**IMPORTANT PRODUCT SERVICE BULLETIN**

Brand: Kunkle  
Models: 6010, 6182, 6186, 6283, 6021, 6121, 6221  
Orifice Sizes: D, E, F, G, H

**Affected Kunkle Products can be identified from the name-plate attributes**

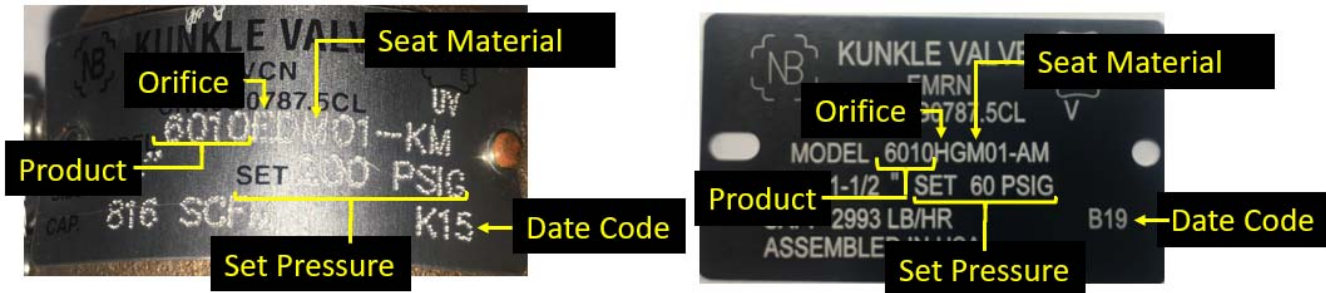
Emerson Automation Solutions recently confirmed a potential discrepancy. Affected valves tested by Emerson, in some instances, may exhibit a substantial process fluid leak below the factory standard seat tightness of 80% of nameplate set pressure. Additionally, Emerson determined through testing that in some instances the affected valves could relieve above nameplate set pressure outside the tolerances permitted by ASME standards. Testing has shown no evidence of capacity reduction below nameplate value.

For valves that are within the affected Kunkle Products, Orifice, Seat Material and Date Code combinations set forth in TABLE 1 below that are in a system(s), applications or stock, Emerson recommends that the customer confirm that the operating limits of the system(s), applications or potential usage are not exceeded using the affected valves. Products not meeting the specific criteria in TABLE 1 are not affected nor included in this bulletin.

The affected valves have the potential for relief over nameplate set pressure as detailed in the TABLE 2 below. If the system(s) operation review determines the system(s) can operate safely with an affected valve, no further action is required. If the review determines the system cannot operate safely with an affected valve, replace the affected valve or perform a field modification, as appropriate.

ASME Code requires that ASME Code valves be sealed to prevent set pressure adjustment. Discrepancy resolution and re-sealing of ASME Code valves must be performed by an ASME VR (Valve Repair) Certificate holder listed in the NB-18 “Redbook”, maintained by the National Board of Boiler and Pressure Vessel Inspectors. Affected valves that have had the discrepancy resolved in the field must be fit with a new nameplate with a C19 or later Date Code.
